UNITED STATES
DEPARTMENT OF THE INTERIOR
BUREAU OF LAND MANAGEMENTOCD Artesia
RECEIVED
MAY 12 2014
NMLC029387CFORM APPROVED
OMB NO. 1004-0135
Expires: July 31, 2010**SUNDRY NOTICES AND REPORTS ON WELLS**
Do not use this form for proposals to drill or to re-enter an abandoned well. Use form 3160-3 (APD) for such proposals.

Cimarex Energy Co. of Colorado
Shugart (Apco) A No. 1

API # 30-015-05629

Permanent Abandonment of Federal Wells
Conditions of Approval

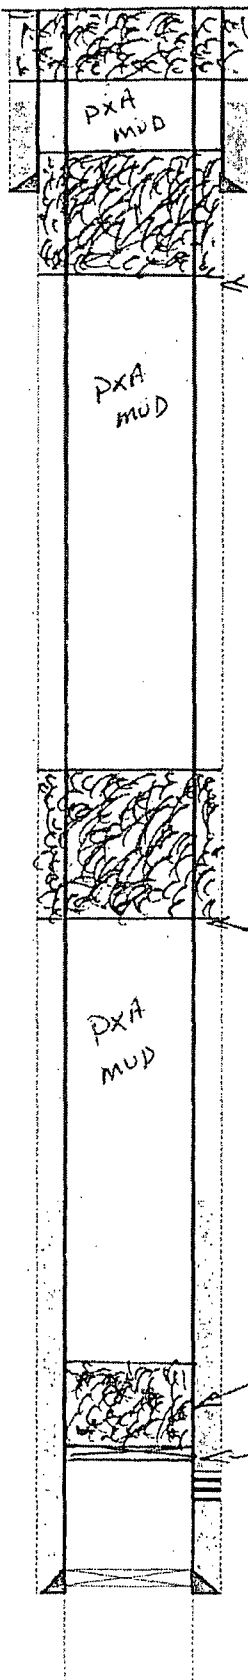
Tag CIBP @ 3520' cap w/25 sx cmt or dbail 35' cmt.
1) SET 5-1/2" CIBP @ 3,200'; PUMP 25 SXS.CMT. @ 3,200'-3,070'; CIRC. WELL.
2) PERF. X ATTEMPT TO SQZ. 55 SXS.CMT. @ 2,050'-1,930' (B/SALT, B/ANHY); WOC X TAG. 1900-1790
3) PERF. X ATTEMPT TO SQZ. 65 SXS.CMT. @ 850'-700' (T/SALT, 8-5/8" SHOE); WOC X TAG. 800-670.
4) PERF. X CIRC. TO SURF., FILLING ALL ANNULI, 100 SXS.CMT. @ 100'-3'.
5) DIG OUT X CUT OFF WELLHEAD 3' B.G.L.; WELD STEEL PLATE ONTO CSGS. X INSTALL GROUND LEVEL DRY HOLE MARKER.

**SEE ATTACHED FOR
CONDITIONS OF APPROVAL***Ground Level Dry Hole Marker Required*
